Norfolk Boreas Offshore Wind Farm

Statement of Common Ground

Highways England

Applicant: Norfolk Boreas Limited
Document Reference: ExA.SoCG-8.D16.V3
Deadline 16

A47 - ACCESS AC160
SCALE - 1:500

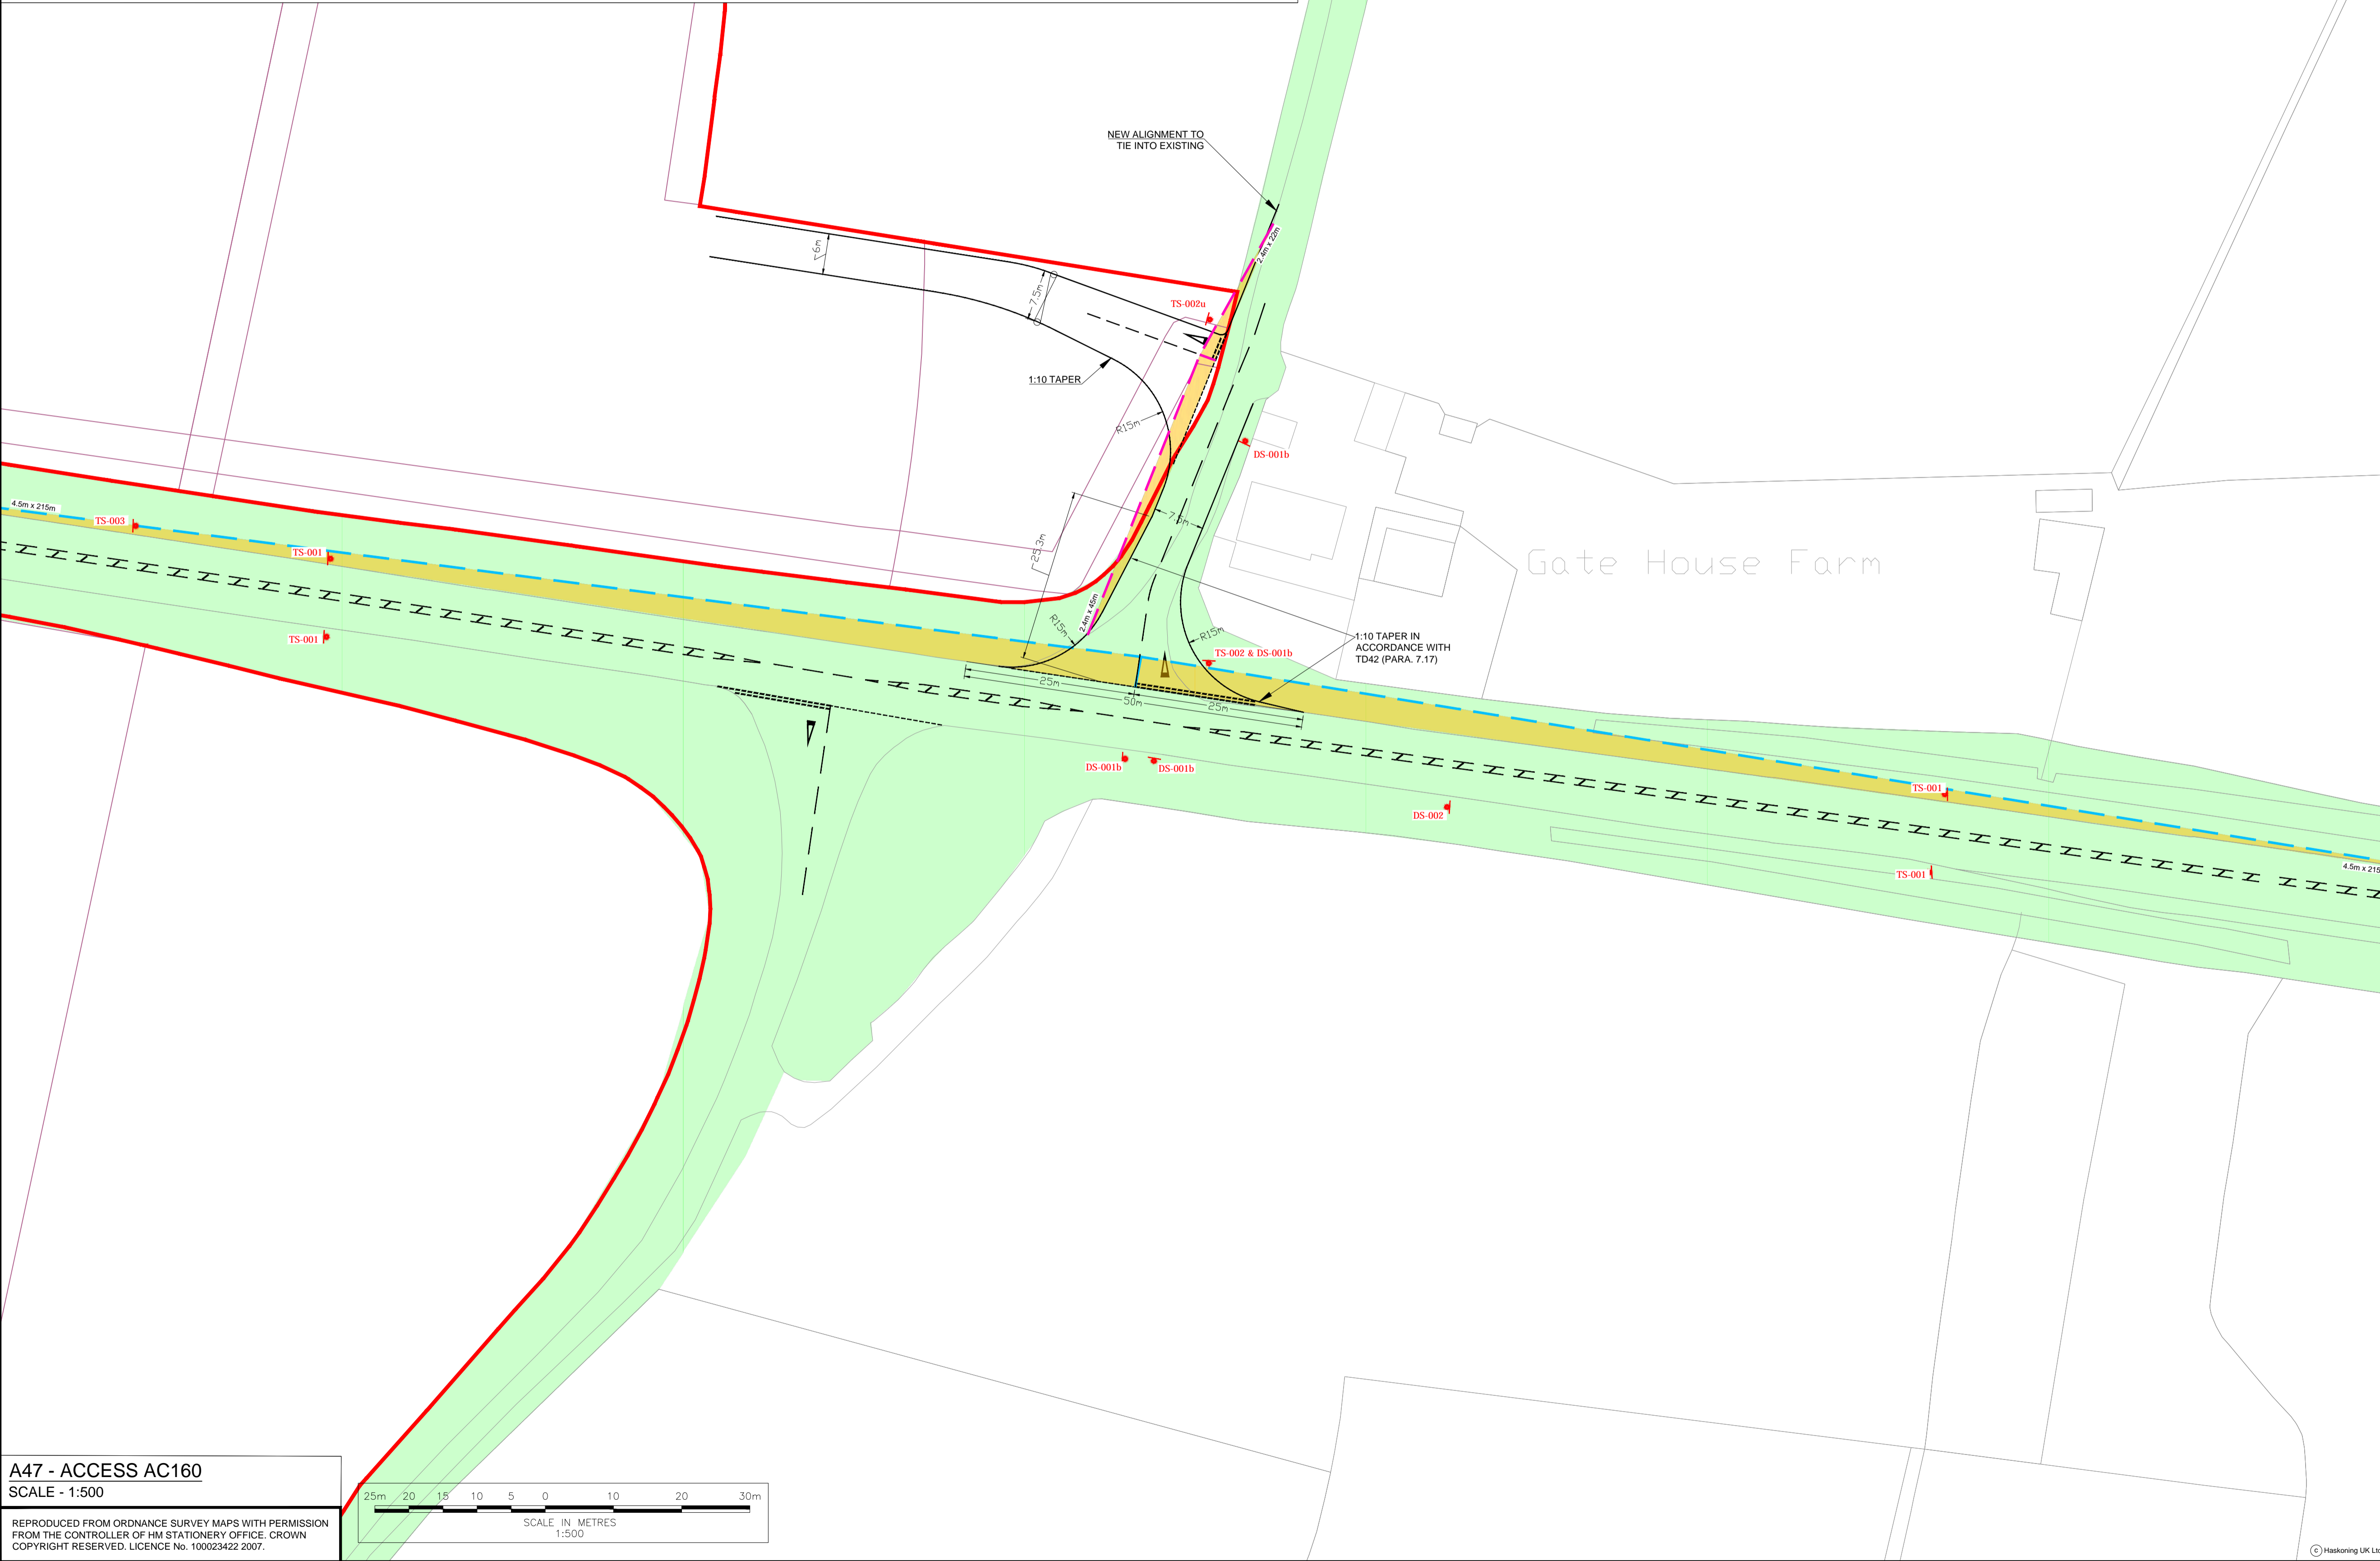
15. The layout of site access junction AC160 illustrated on Drawing PB4476-DR025 D0.1 appears to provide satisfactory geometry to accommodate heavy vehicles turning to and from the A47. There is no suggestion that the use of this junction by vehicles accessing the works would give rise to a queue of stationary traffic within Bushy Common Road waiting to enter the site, such as would risk generating a queue of traffic back to the A47, some 50m away.

19. The layout of the improved junction between the A47 and Bushy Common Road, illustrated on Drawing PB4476-DR025 D0.1, appears to provide in full for the requirements of DMRB Design Standard TD42 for this type of junction. In addition, the swept path plots shown on Drawings PB4476-DR026 and 027 show that it can accommodate heavy vehicles turning on and off the A47 without clipping kerb lines, and without encroaching on the wrong side of the A47 or the minor road.

TITLE
A47 / DEREHAM ROAD JUNCTION
ARTICULATE VEHICLE SPA

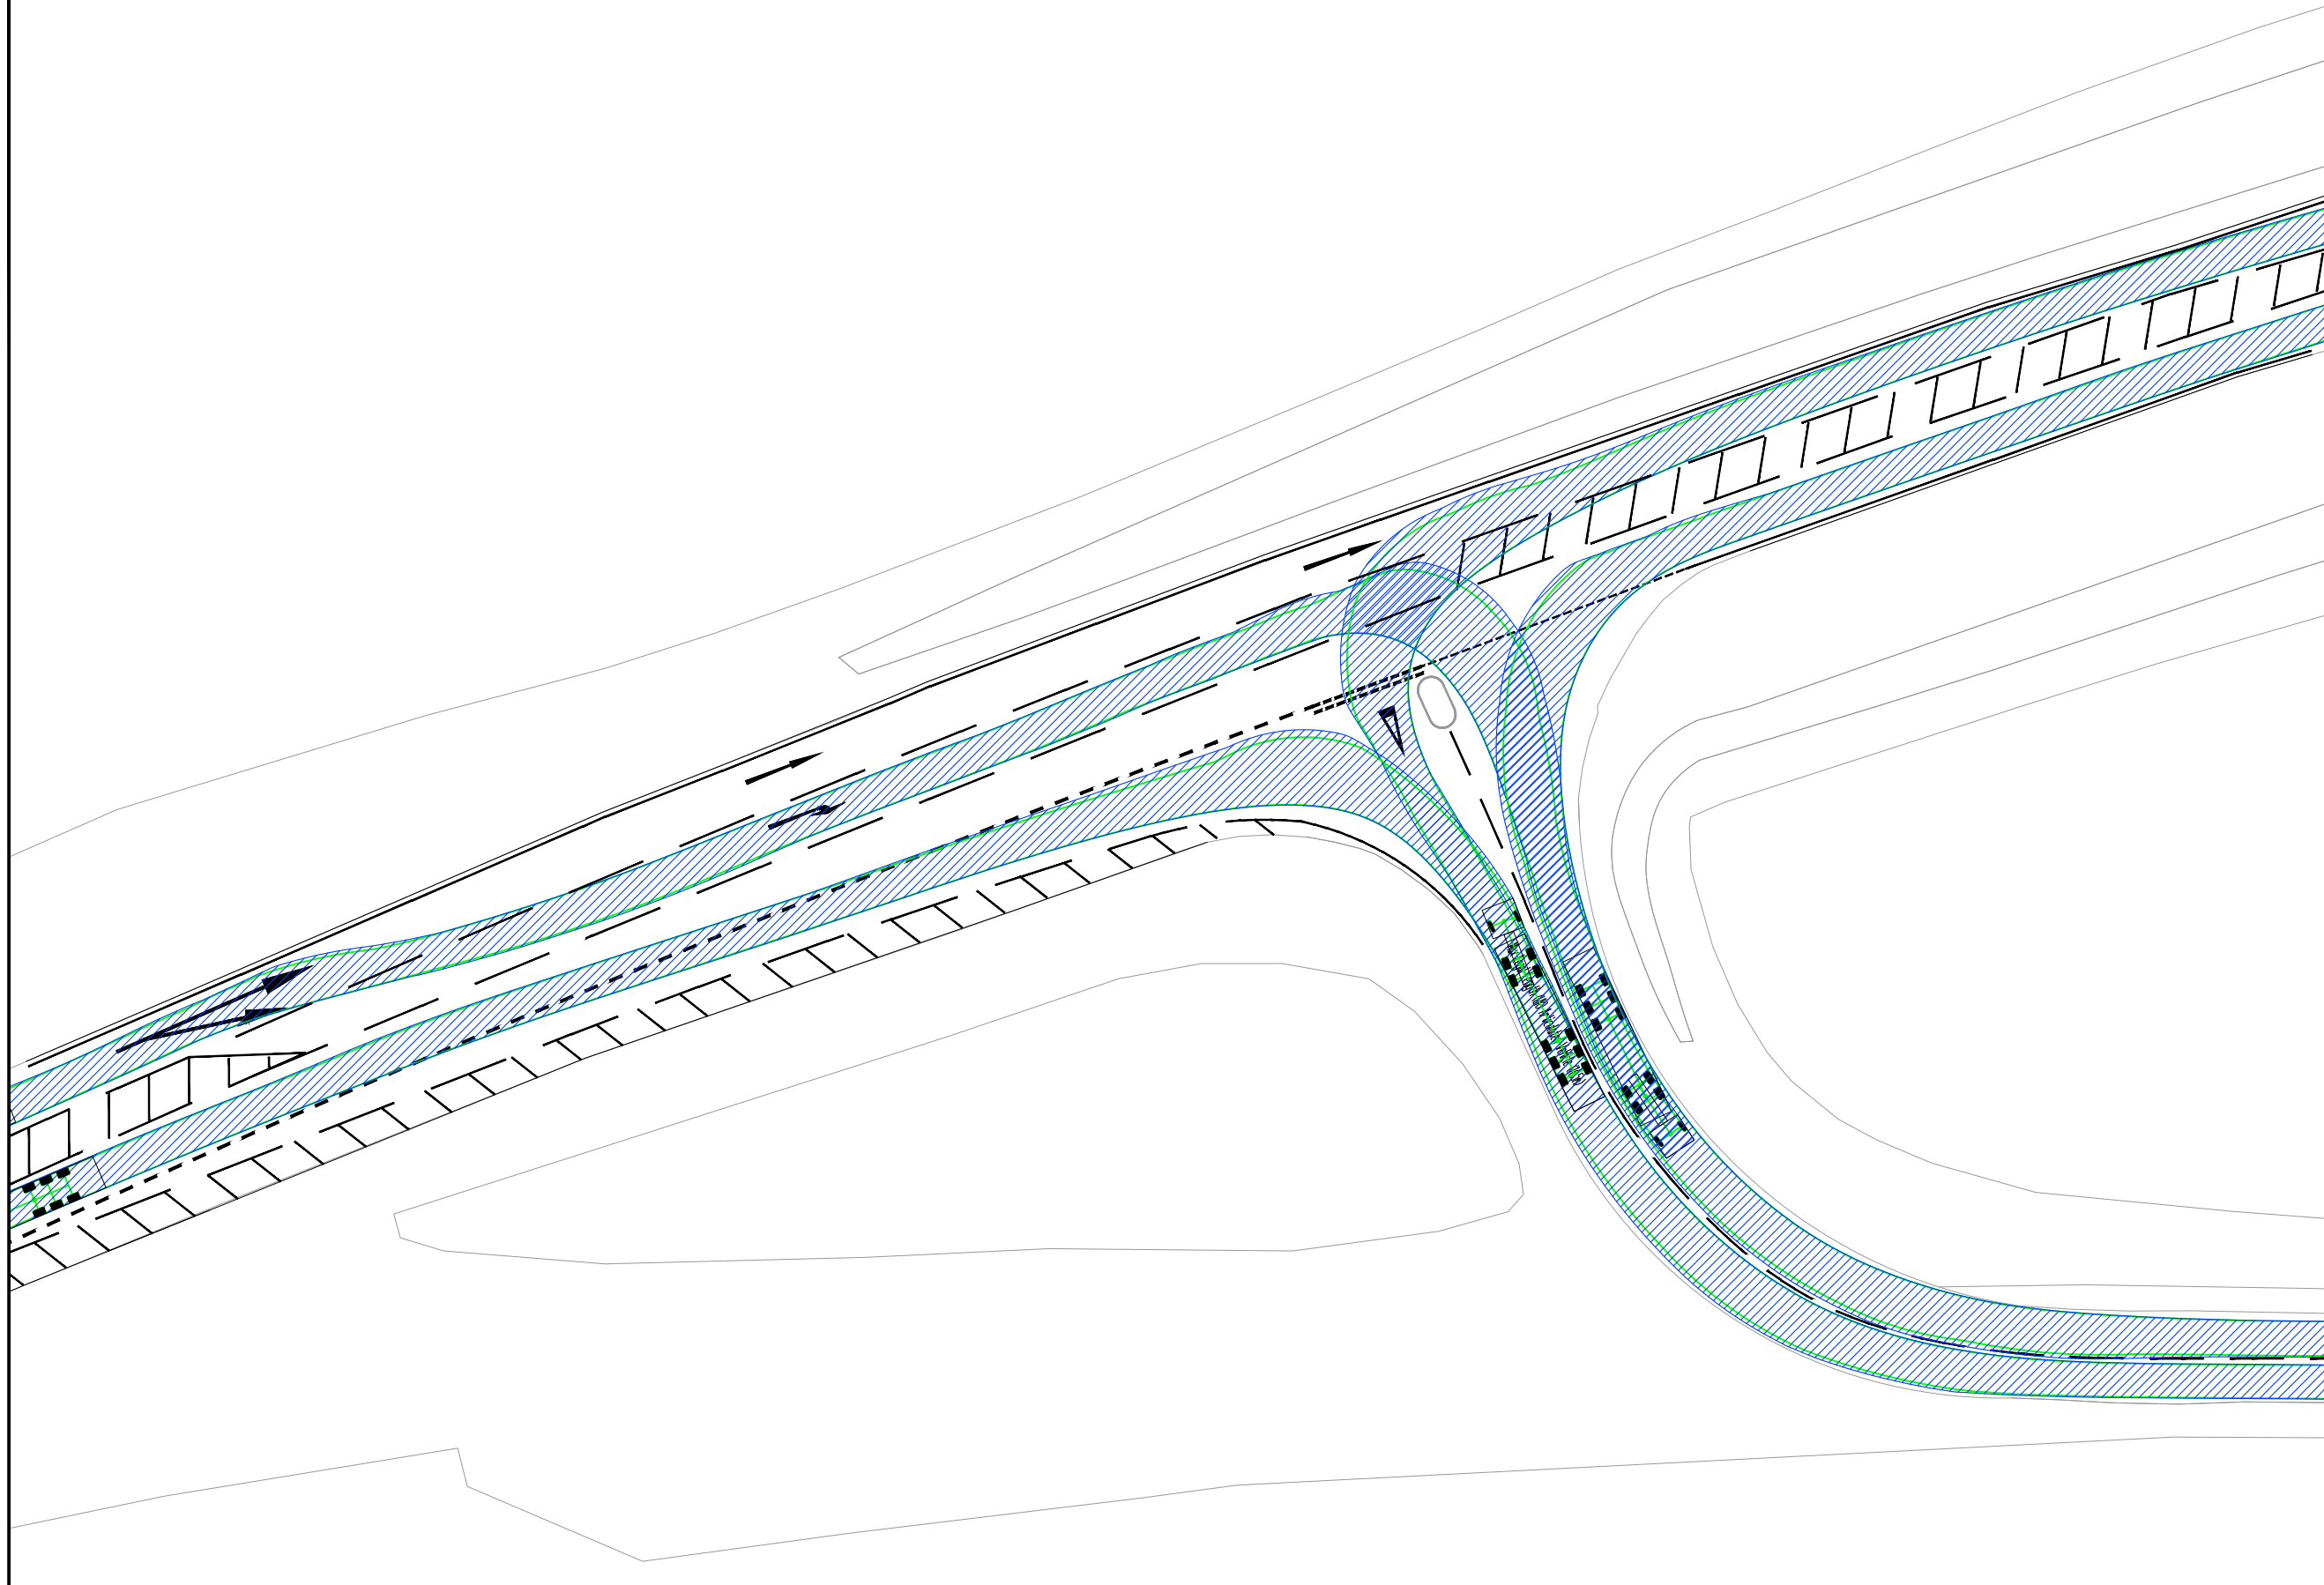
24. This is an existing junction of a relatively high standard. Whilst it does not appear to conform exactly to current DMRB standards, it broadly resembles the layout prescribed for a ghost island junction where the design speed of the main road is 100 km/hr, with corner radii of 20m, consistent with the highest standard required by TD42 at Para 7.17(e). There is a merge taper on to the A47 westbound which would not be provided were this junction being built today (TD42 para 7.59 refers). The swept path plots illustrated on Drawings PB4476 028 and 029 show that the junction can accommodate heavy vehicles turning on and off the A47 without clipping kerb lines, and without encroaching on the wrong side of the A47 or the minor road. No modifications are proposed at this junction to mitigate the impact of the proposed development and AECOM agree that none are required, other than the clearance of overgrown foliage from visibility splays.
